UNITED STATES PATENT AND TRADEMARK OFFICE

APPLICATION NO.	FILING DATE	FIRST NAMED INVENTOR	ATTORNEY DOCKET NO.	CONFIRMATION NO.
10/509,478	09/29/2004	Marten Erik Van Dijk	NL 020269	1367

Office Action Summary	Application No. 10/509,478	Applicant(s) VAN DIJK ET AL.	
	Examiner Mujtaba K. Chaudry	Art Unit 2133

DETAILED ACTION

Fig. 7

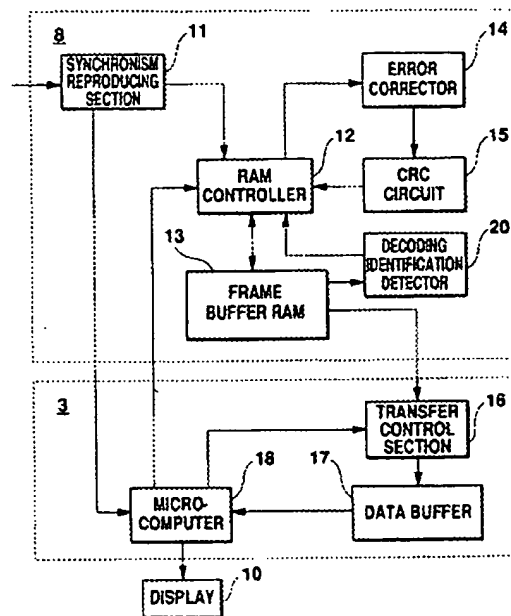
However, Kimura et al. (herein after referred to as single entity: Kimura) in an analogous art, substantially teaches (Figure 7) a digital signal is composed of a frame which consists of a predetermined number of blocks in the vertical direction, a block consisting of a predetermined number of bits in the horizontal direction and having a horizontal parity (error correcting code) for correcting error in the horizontal direction and a vertical parity for correcting errors in the vertical direction. The block also has a control bit for determining whether the error correction in the horizontal direction is to be carried out only once. A decoding identification detector (20) detects the content of the control bit, a controller (12) controls the re-writing of the digital signal into a frame buffer (13) after the error correction of the digital signal in the vertical direction by an error corrector (14). The controller (12) also controls the provision of the digital signal stored

in the buffer (13) to the error corrector (14) according to the content of the control bit, determining whether the second error correction in the horizontal direction is to be carried out. Therefore it would have been obvious to one of ordinary skill in the art at the time the invention was made to embed horizontal parities within the shortened row code words within the method and apparatus of Kondo. This modification would have been obvious to one of ordinary skill in the art because one of ordinary skill would have recognized that by embedding horizontal parities within the shortened row code words would have increased the error detection and correction capability.

However, Kimura et al. (herein after referred to as single entity: Kimura) in an analogous art, substantially teaches (Figure 7) a digital signal is composed of a frame which consists of a predetermined number of blocks in the vertical direction, a block consisting of a predetermined number of bits in the horizontal direction and having a horizontal parity (error correcting code) for correcting error in the horizontal direction and a vertical parity for correcting errors in the vertical direction. The block also has a control bit for determining whether the error correction in the horizontal direction is to be carried out only once. A decoding identification detector (20) detects the content of the control bit, a controller (12) controls the re-writing of the digital signal into a frame buffer (13) after the error correction of the digital signal in the vertical direction by an error corrector (14). The controller (12) also controls the provision of the digital signal stored in the buffer (13) to the error corrector (14) according to the content of the control bit, determining whether the second error correction in the horizontal direction is to be carried out. Therefore it would have been obvious to one of ordinary skill in the art at the time the invention was made to embed horizontal parities within the shortened row code words within the method and apparatus of Kondo. This modification would have been obvious to one of ordinary skill in the art because one of ordinary skill would have recognized that by embedding horizontal parities within the shortened row code words would have increased the error detection and correction capability.
